PLANNING BOARD

Tuesday, December 10, 2024 at 4:30 PM
Room 24 (Ground Level of City Hall) and
Zoom

Drawing Name:	PRE-DEVELOPMENT WATERSHED MAP
Project:	Home 2 Suites - 203 Fore Street Portland, Maine
Client:	Chatham Portland DT, LLC c/o Chatham Lodging Trust 222 Lakeview Avenue- Suite 200, West Palm Beach, FL 33401

C-3.0

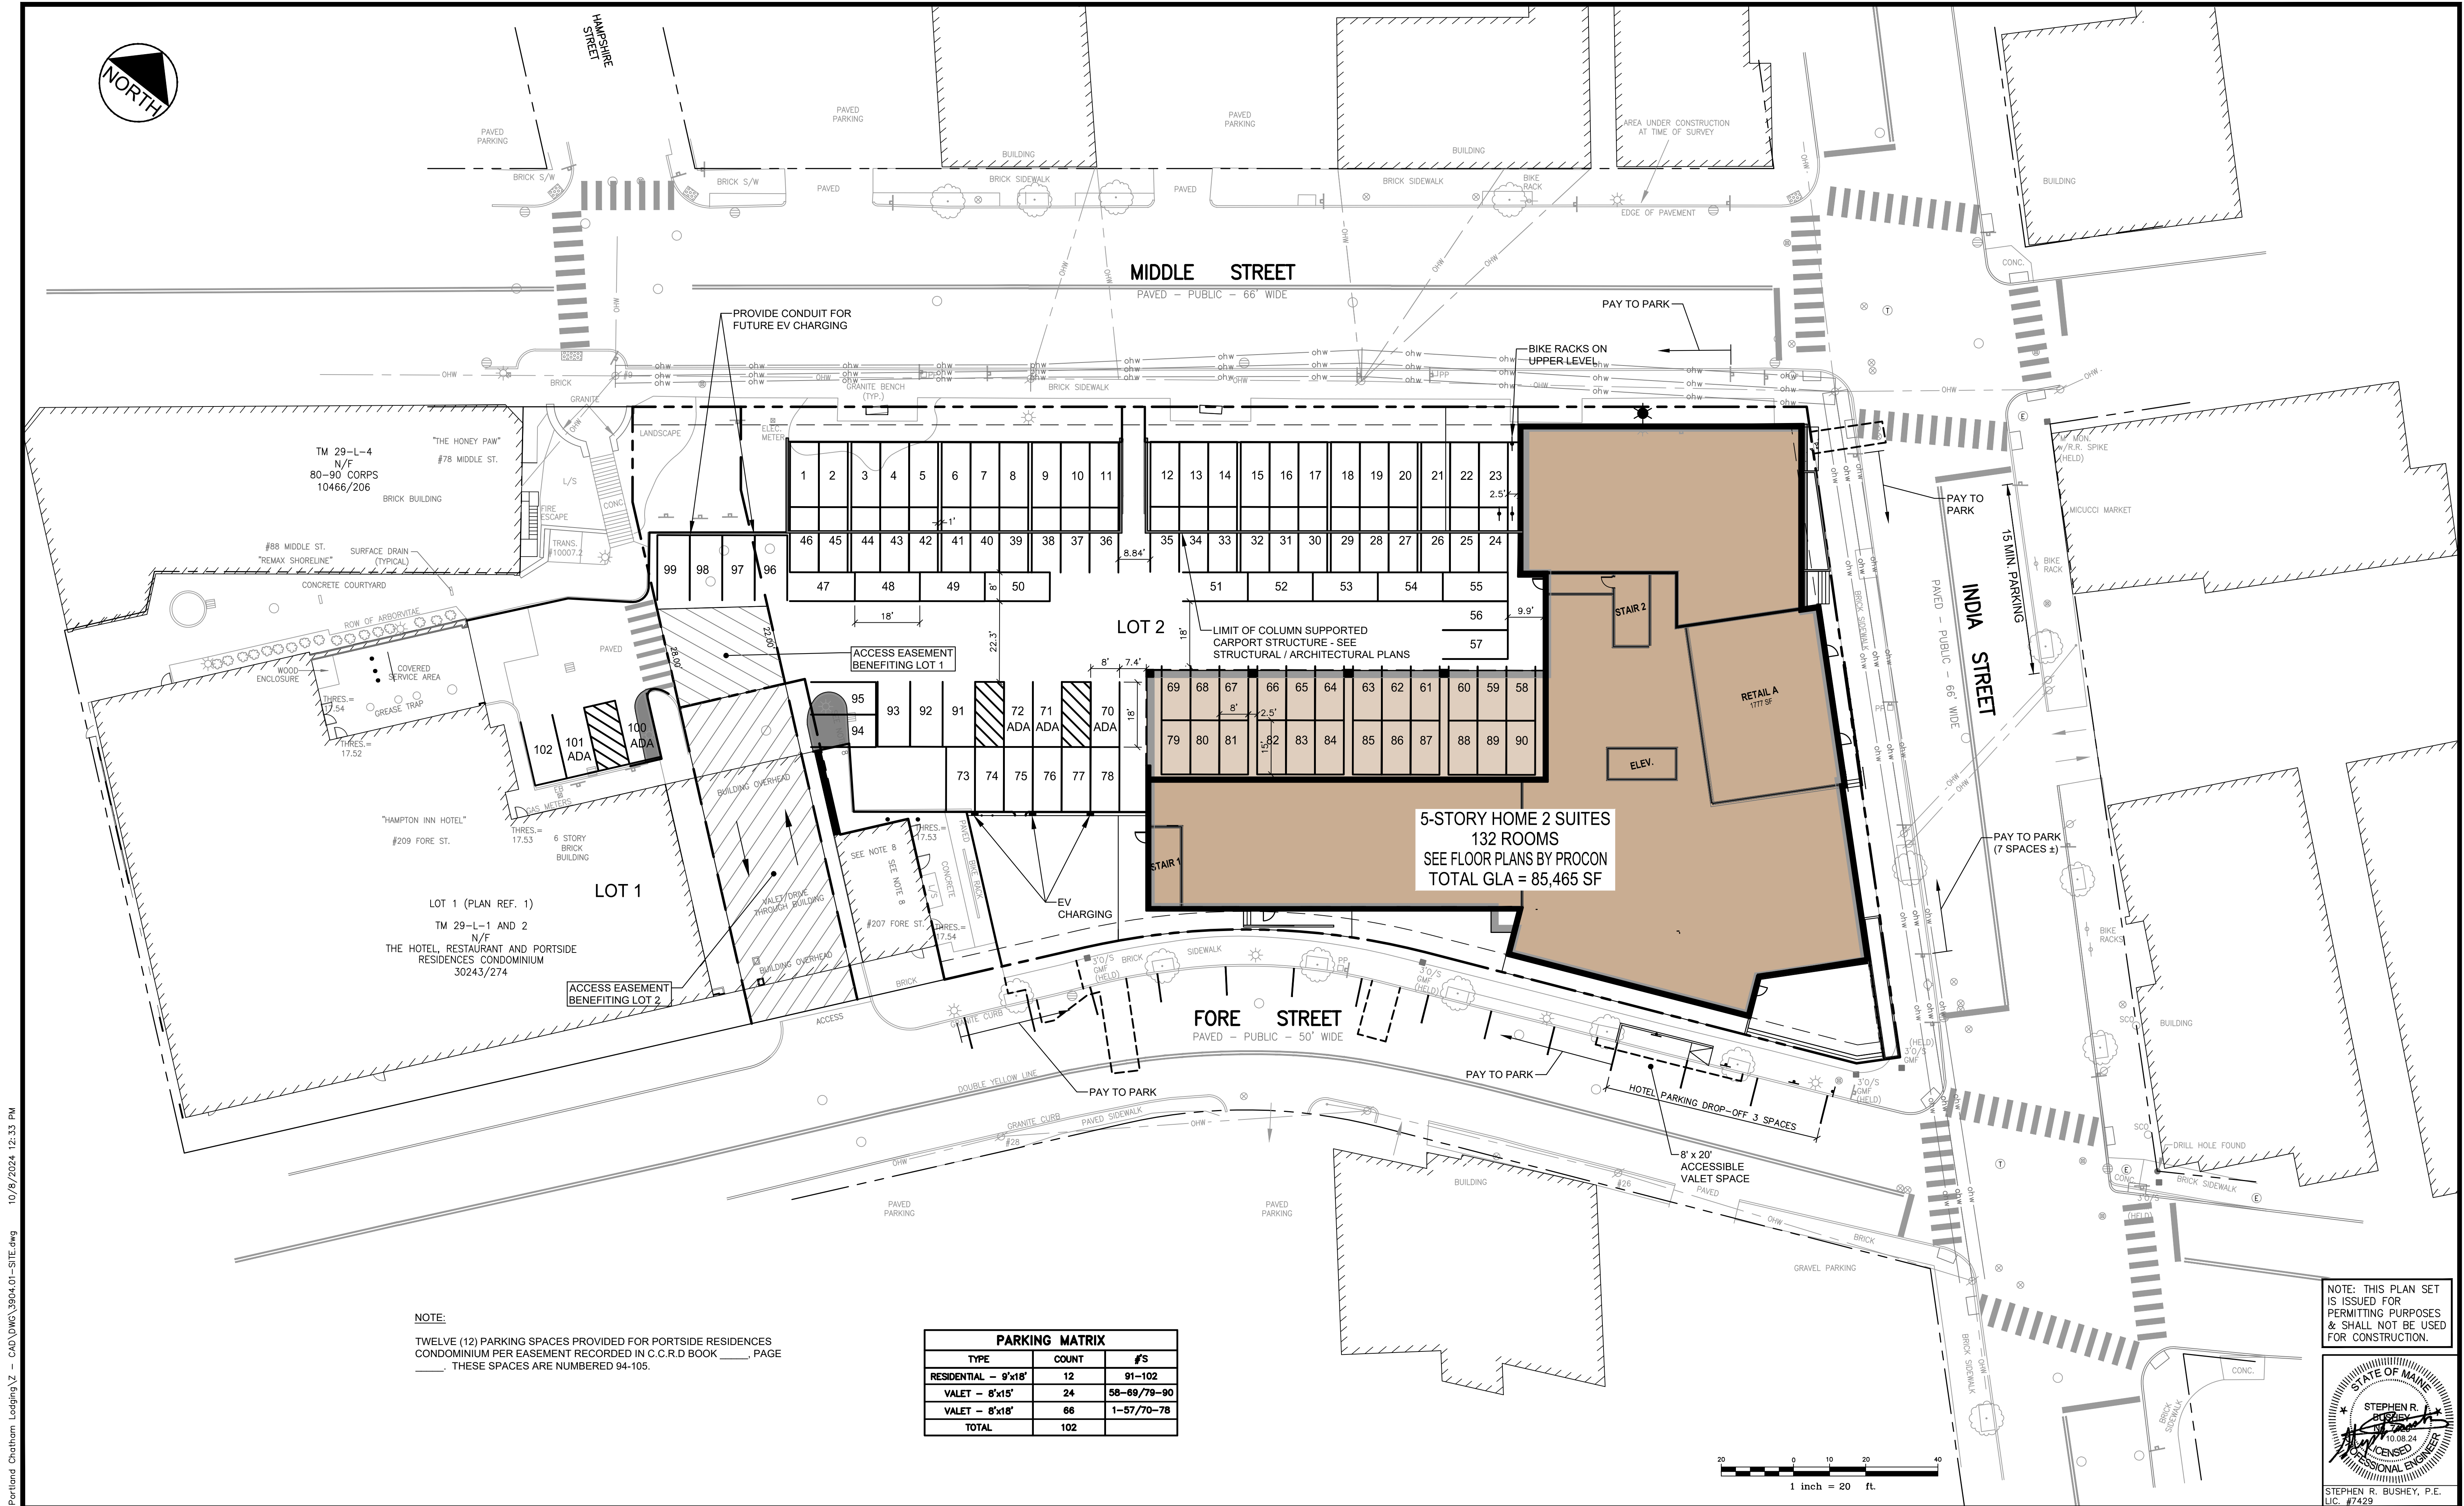
- *C-3.0 – Remove special pavers from the ROW*

- *C-3.0 – Show the proposed pavement cuts for utility connection in the public ROW.*

Response: A note has been added to C-3.0 to coordinate with Dept. of Public Works for final moratorium pavement restoration. This will include a full street width pavement restoration subject to Section 4.09 Five Year Street Restoration Requirements of the City Technical Standards and Rules and Regulations for Excavation Activity within the Public ROW. All restoration shall extend at least 20 feet from the edge of road pavement disturbance.

Drawing No.	C-4.0
-------------	-------

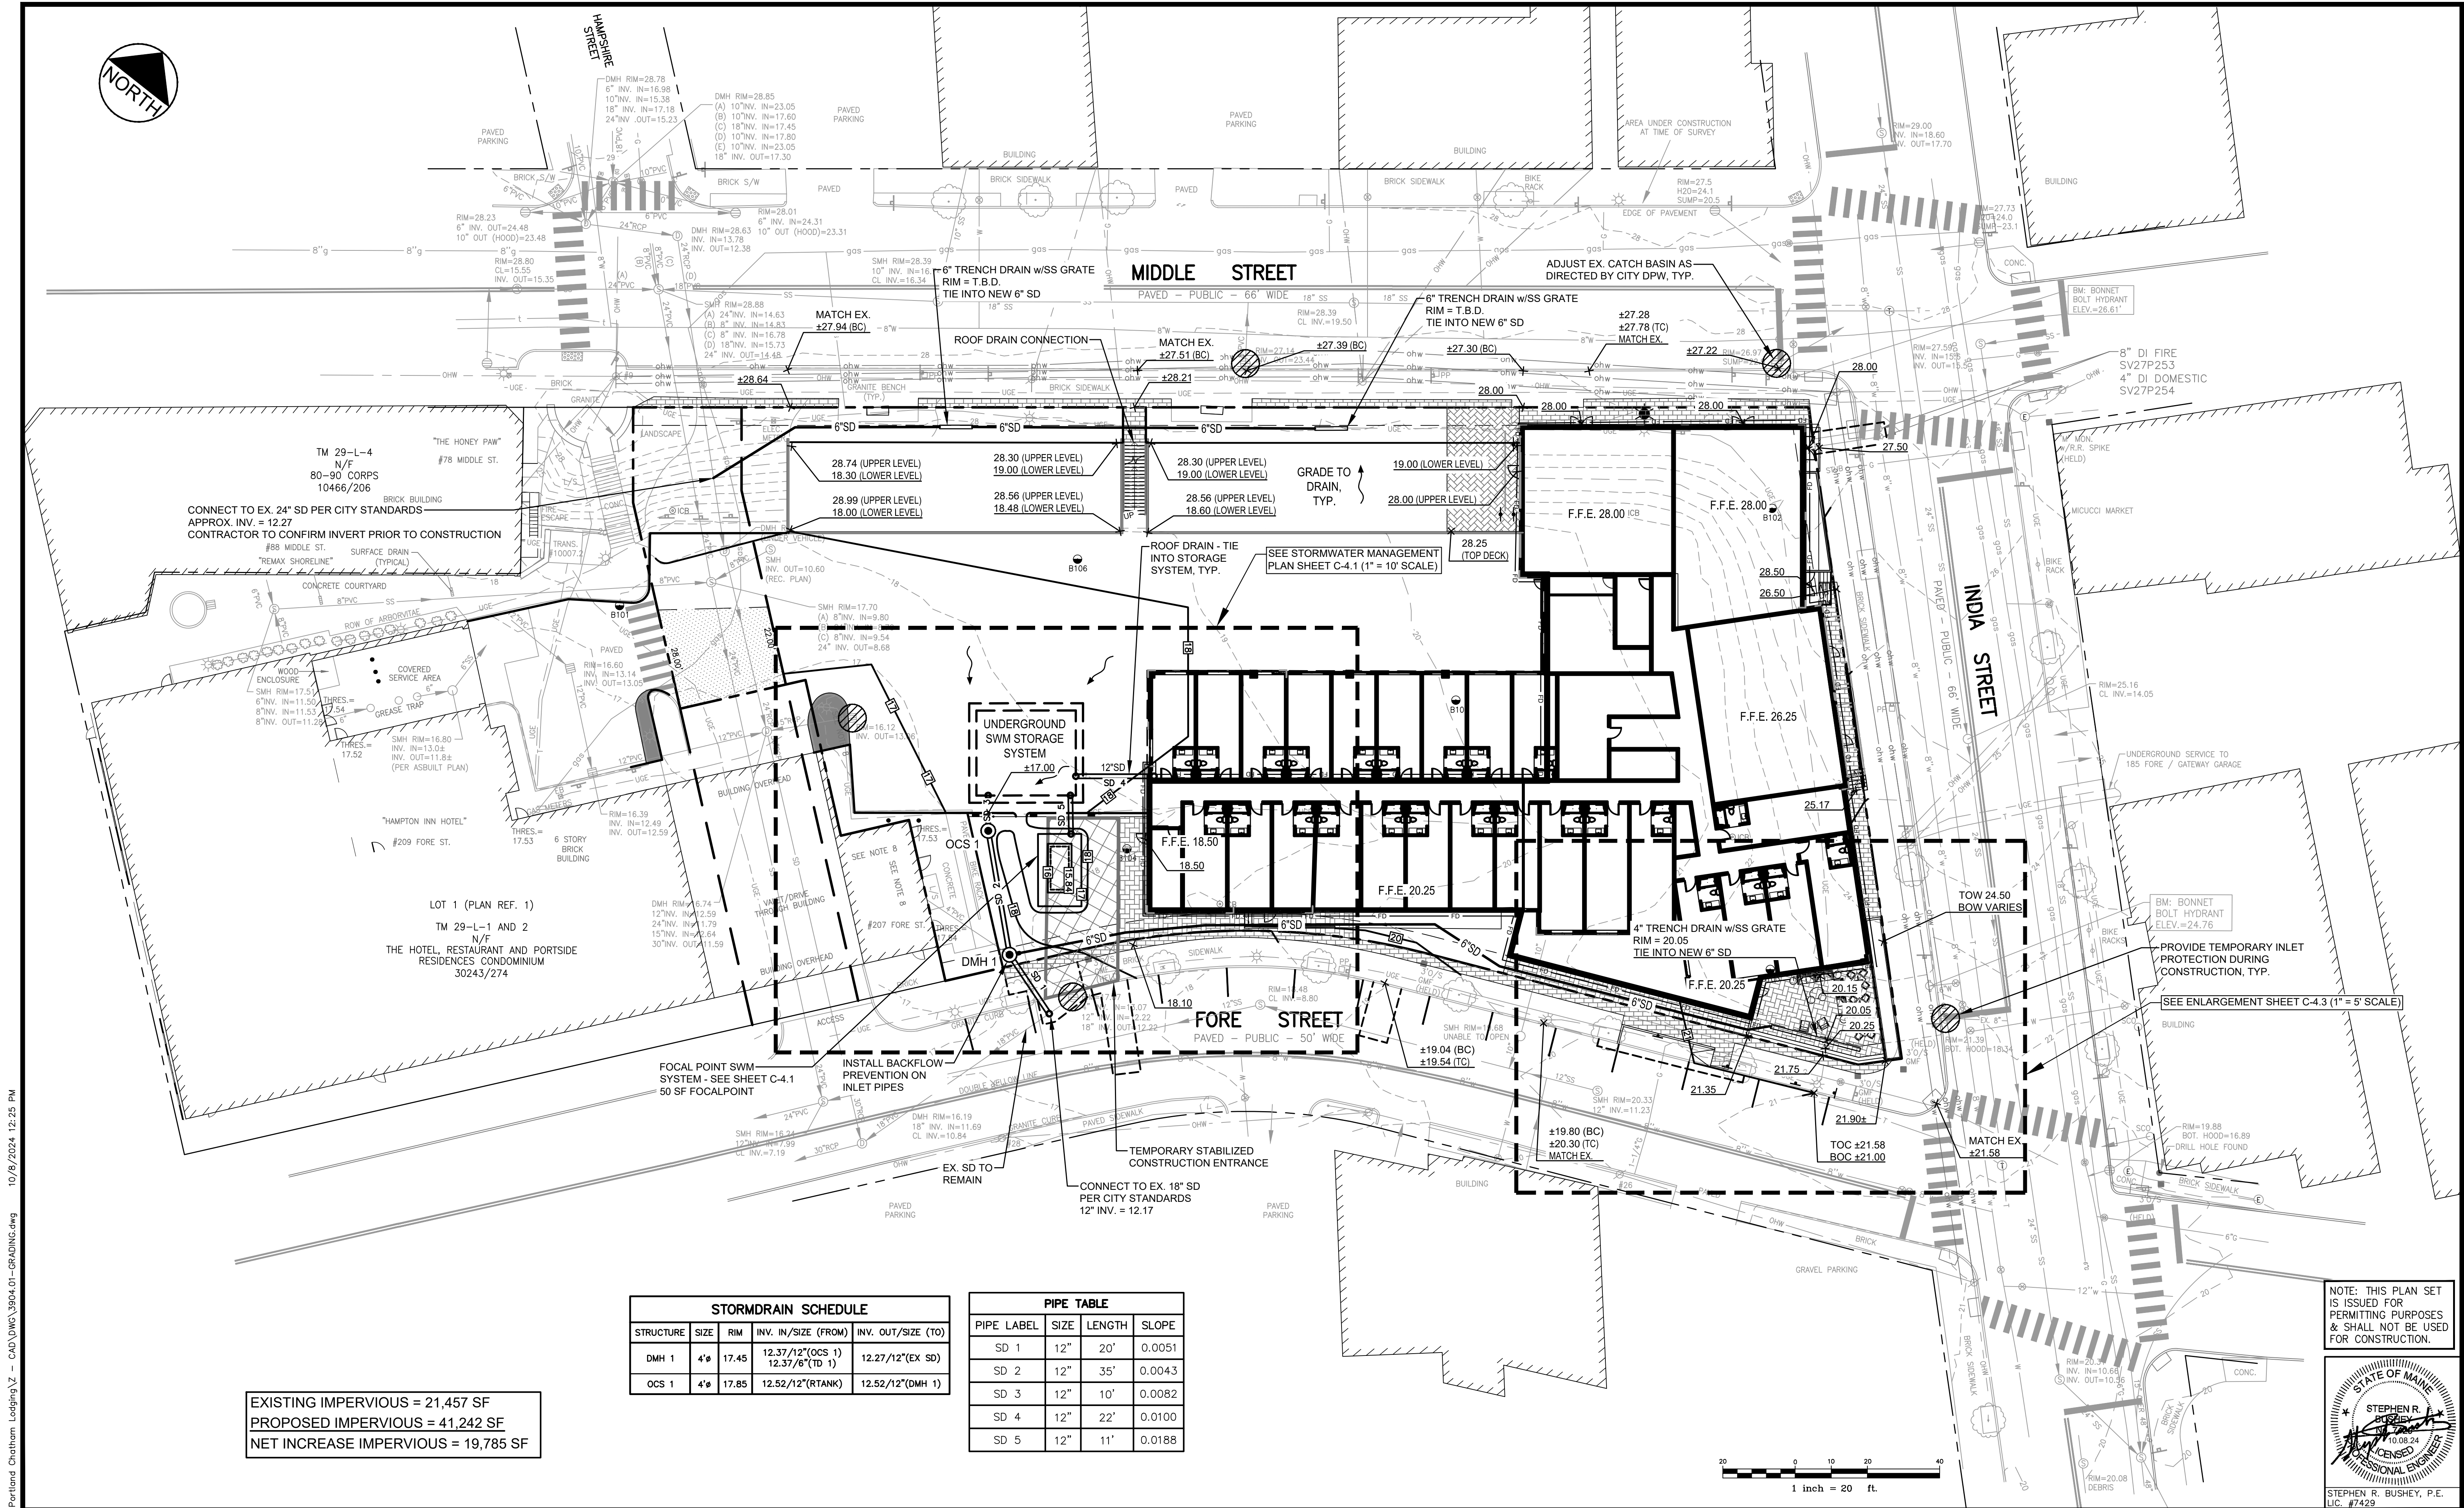
- *C-4.0 – The plans do not have enough information to determine if the existing sidewalks are accessible (ADA compliant). The applicant shall update the plans. Spot grades and slopes shall be added to plans at locations where existing sidewalk meets proposed (driveways, egress locations, pedestrian ramps, accessible crossings, sidewalks and steps)*

Response: C-4.0 has been updated to provide additional grading and drainage details.

Additional detailing on Sheet C-4.0 is provided to show the proposed surface grading to the Focalpoint, the location of the stormwater BMP's and drainage system. Details for the Focalpoint and R-tank chambers have been included on Sheets C-4.1 and C-4.2 along with a 10' scale plan showing the system components in greater detail.
